Council Comments - SSD-76220734 - 156-164 Ocean Street, Narrabeen

Thank you for your correspondence inviting Northern Beaches Council's advice on the Environmental Impact Statement for Indigo By Moran - 156 Ocean Street Narrabeen - SSD-76220734.

Appendix 1 Northern Beaches Council Submission - Detailed Supplementary Comments - SSD-76220734 - 156-164 Ocean Street, Narrabeen

Loading/ Servicing

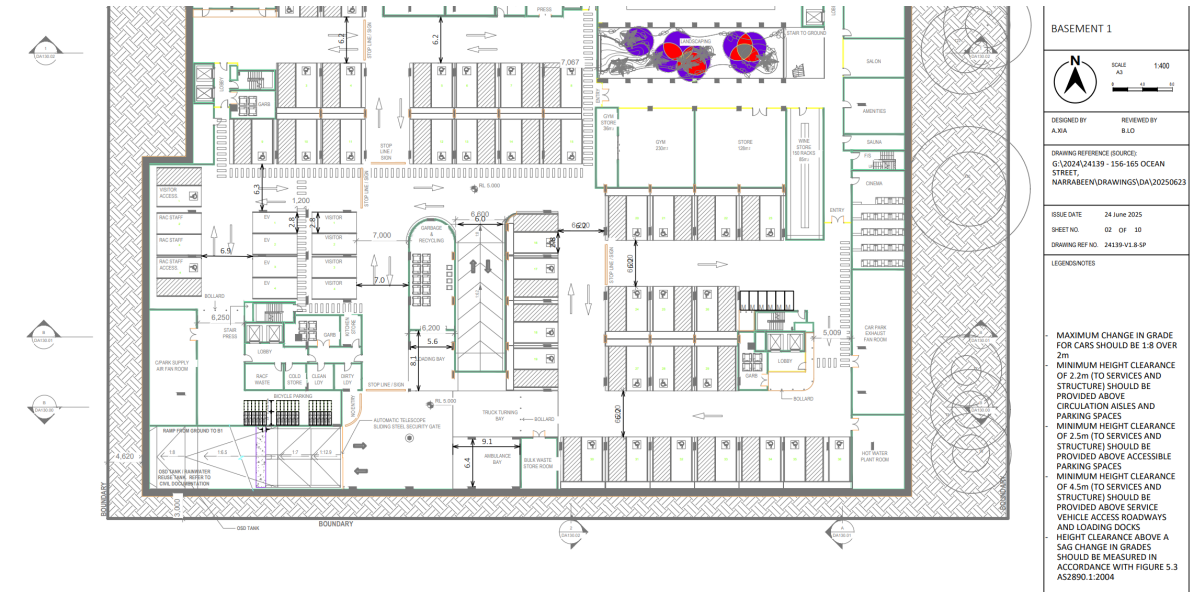
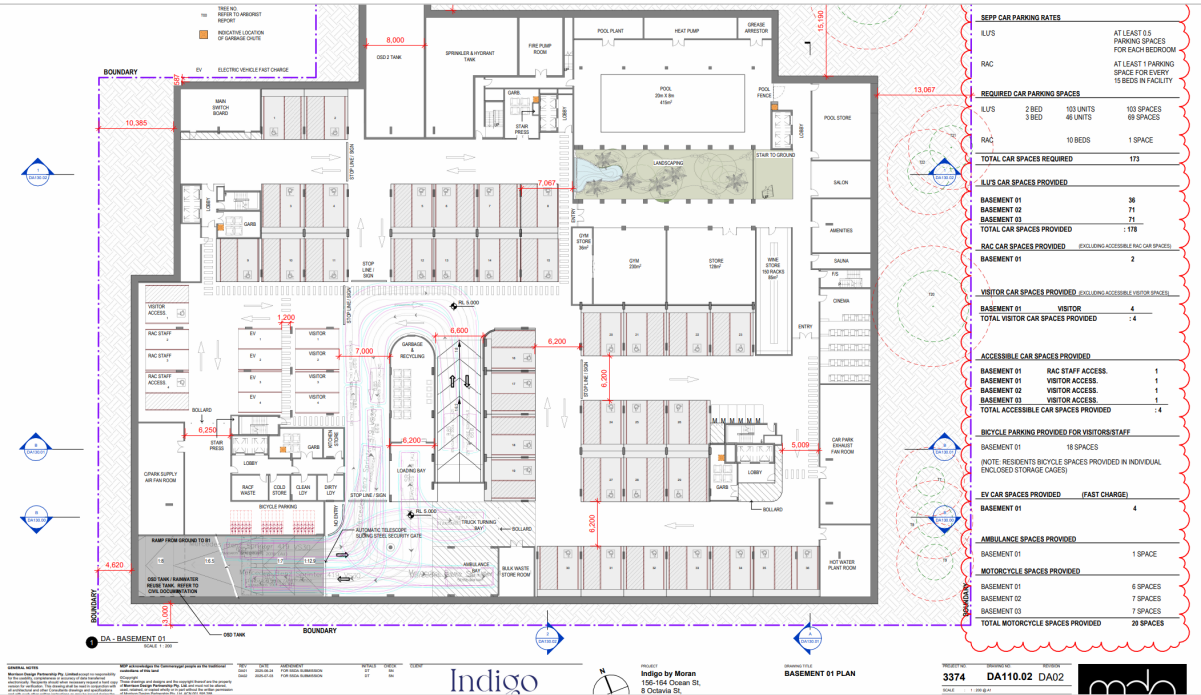
The development should cater for servicing of waste by a 10.5m waste collection vehicle. The loading bay appears to be sized only to accommodate a small rigid vehicle which is considered inadequate for a development of this scale. Turning and overhead clearance (4.5m) for access by a vehicle of this size must be demonstrated.

Apart from waste collection it is considered unlikely that all other servicing needs will be completed by SRVs or mini vans. Removalist trucks will be required on a regular basis for a development comprised of 149 ILU's and 10 aged care beds. Off-street parking for at least a MRV to facilitate access for removalist trucks and other large servicing vehicles, in addition to the loading bay for garbage and recycling is considered necessary.
